Office Action Summary	Application No. 09/917,959	Applicant(s) TAGUCHI, TOMOYUKI	
	Examiner emily y chan	Art Unit 2829

DETAILED ACTION

Claims 1-12 are rejected under 35 U.S.C. 103(a) as being unpatentable over Suzuki et al ('030) in view of Tomitam ('061).

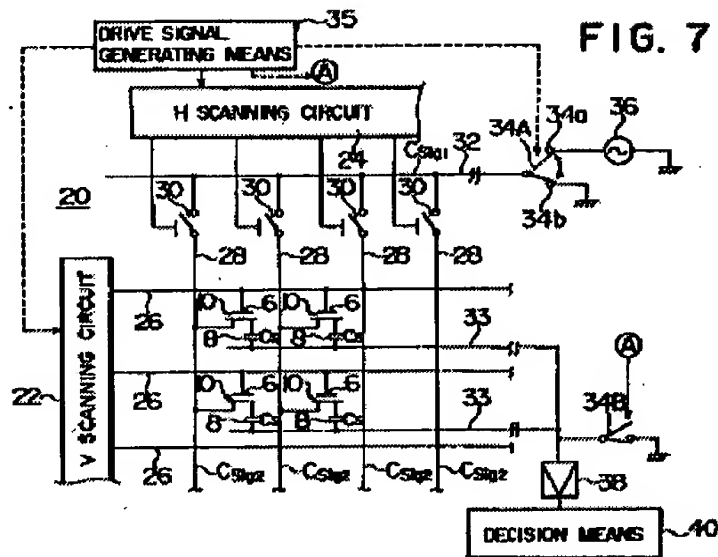
Suzuki et al ('030) disclose an inspection method for an array substrate as claimed (see fig 7) below, in which the array substrate comprises: a substrate (5); a plurality of gate lines (26); a plurality of signal lines (28); a plurality of common power source terminal line (33); a plurality of switching elements (6, 30) electrically connected respectively to the a plurality of gate lines (26) and to the a plurality of signal lines (28); and a plurality of storage capacitors (8) electrically connected respectively to the plurality of common power source terminal line (33) and to the plurality of switching elements (6) (see 5, lines 30-35). Suzuki et al ('030) expressly teach (see col. 7, lines 12-20 and col. 11, lines 1-5) that:

(1) Applying voltage from the plurality of common power source terminal lines (33) to the plurality of storage capacitors (8) (See Col. 7, lines 14-16 "the voltage from the common power source terminal line 33 is applied to the capacitor element 8");

(2) Applying voltage signal (V1) from the plurality of signal lines (28) to the plurality of storage capacitors (8) via a plurality of switching elements (6, 30); and

(3) Measuring quantities of charge stored in the storage capacitors (8) by a circuit (40) (see Col. 7, lines 51-55) based on potential difference between the two voltage signals (V1 and " voltage from the common power source terminal line 33" (see col. 7, lines 12-20, 35-38 and lines 52-55).

Suzuki et al ('030) does not teach the step of applying pulse signals from a plurality of storage capacitor lines to the plurality of storage capacitors.

FIG. 10

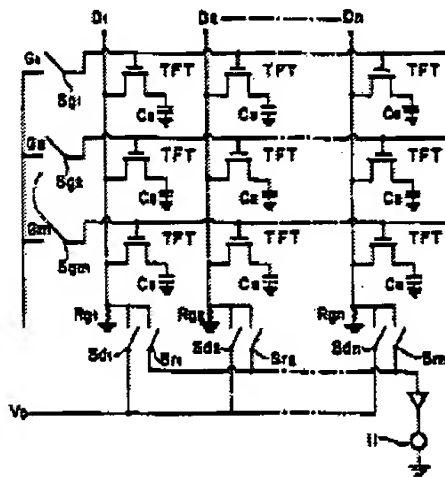
Takahashi et al ('300) disclose a method and apparatus for testing TFT-LCD and expressly teach a circuit (waveform analyzer 11) for measuring the quantities of

discharge released from the storage capacitor (see Fig 10 below) is connected to signal lines (D1... Dn) through relays (Sr1... S_rn).

It would have been obvious to one of ordinary skill in the art at the time the invention as made to incorporate the teaching of Takahashi et al ('300)' measuring circuit connected to the signal lines into Suzuki et al ('030) in view of Tomitam ('061)' s device, because by using a relay, whether or not the TFTs corresponding to the individual pixels are properly connected can be determined efficiently as disclose by Takahashi et al ('300) (see col. 6, lines 25-30).
